P0299 Ellenor Hospice

KEY - Amendments to current approved drawing 2101 Rev P8

Project
Ellenor Hospice

Drawing
Proposed Elevations

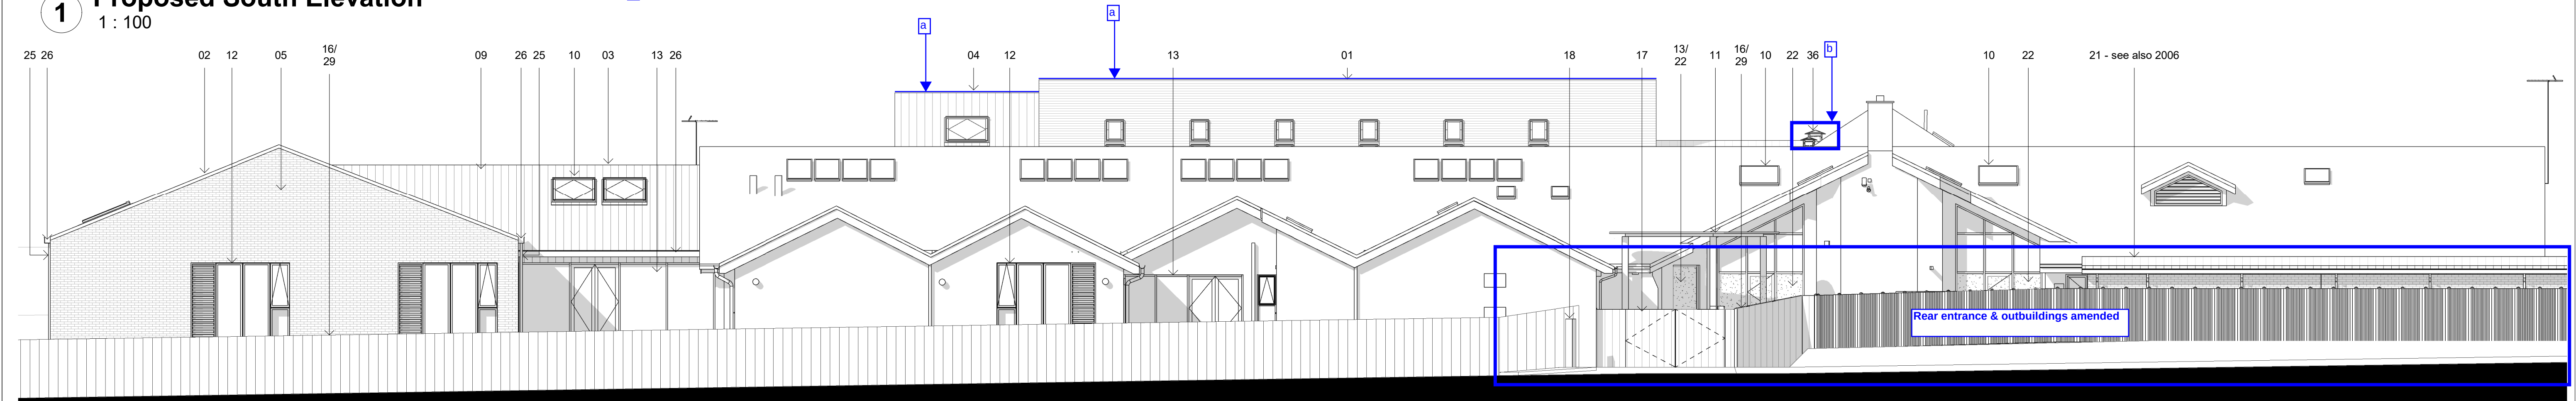
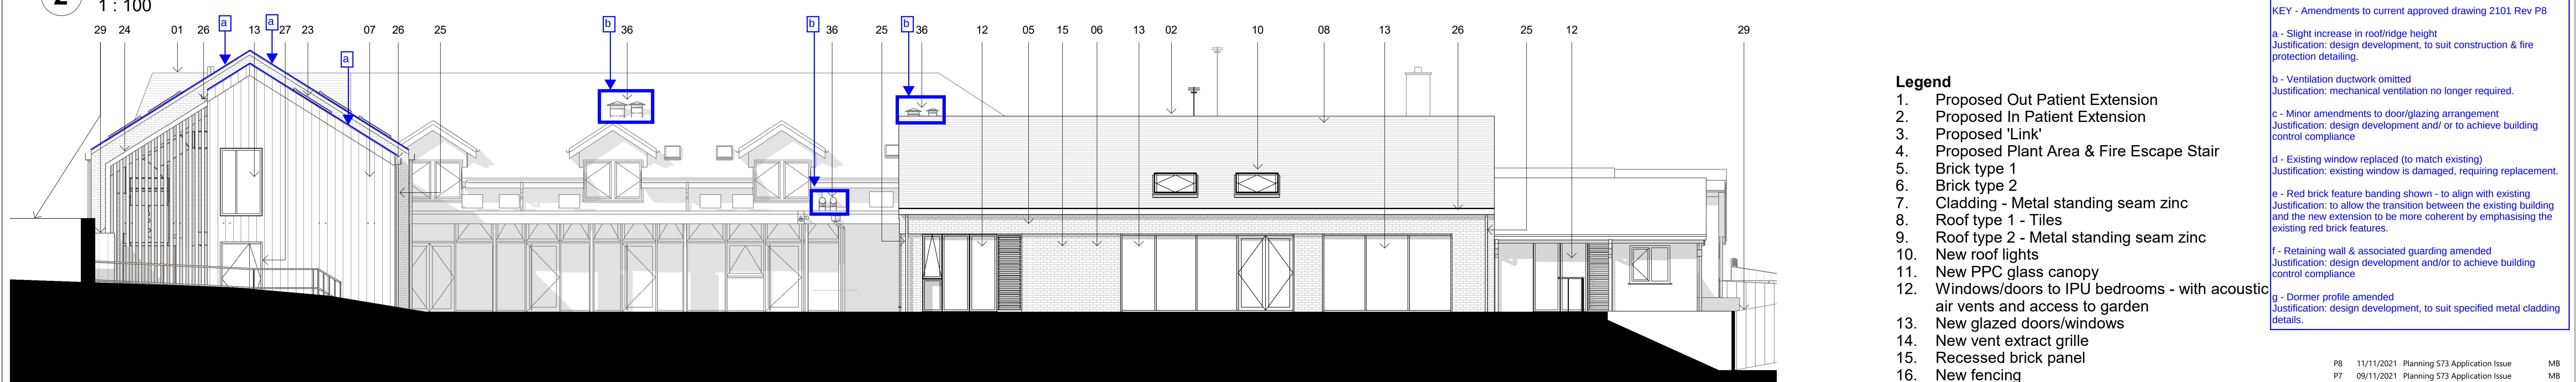
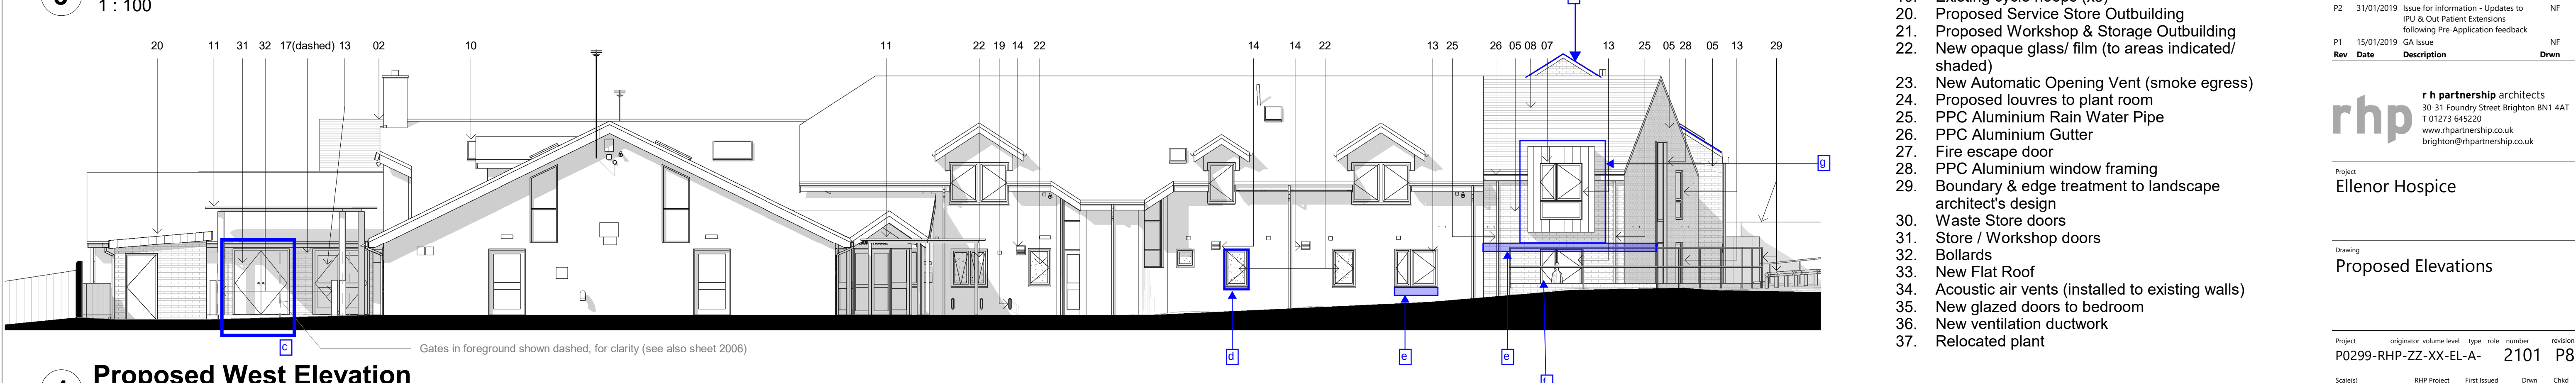
a - Slight increase in roof/ridge height
Justification: design development, to suit construction & fire protection detailing.

b - Ventilation ductwork omitted
Justification: mechanical ventilation no longer required.

c - Minor amendments to door/glazing arrangement
Justification: design development and/ or to achieve building control compliance

d - Existing window replaced (to match existing)
Justification: existing window is damaged, requiring replacement.

e - Red brick feature banding shown - to align with existing
Justification: to allow the transition between the existing building and the new extension to be more coherent by emphasising the existing red brick features.

f - Retaining wall & associated guarding amended
Justification: design development and/or to achieve building control compliance

g - Dormer profile amended
Justification: design development, to suit specified metal cladding details.
